Re: *IN THE MATTER OF: THE 2017 INTEGRATED RESOURCE PLAN OF BIG RIVERS ELECTRIC CORPORATION—CASE NO. 2017-00384*

**2017 INTEGRATED RESOURCE PLAN OF
BIG RIVERS ELECTRIC CORPORATION**

**Response to Commission Staff's
First Request for Information
dated June 22, 2018**

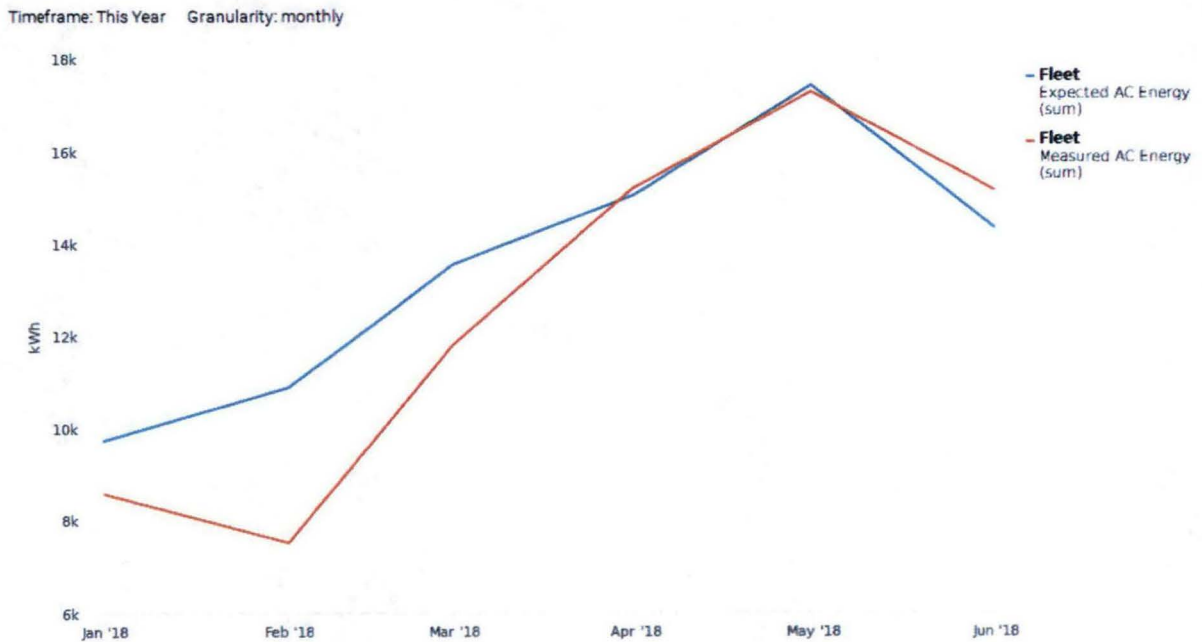
1 **Item 10)** *Refer to the IRP, Chapter 3, Section 3.10, page 46, regarding Big*
2 *Rivers' seven solar power facilities. Provide an update on the status of the*
3 *construction of these projects and, for those solar facilities that have been*
4 *completed and operational, provide a comparison showing their*
5 *performance relative to the original expectations.*

7 **Response)** All seven solar arrays have been constructed and have been operating
8 normally since mid-December 2017. The graph on the following page shows monthly
9 kWh production compared to the modeled expectation for the entire fleet of seven
10 arrays from January 1, 2018, through the date of this response.
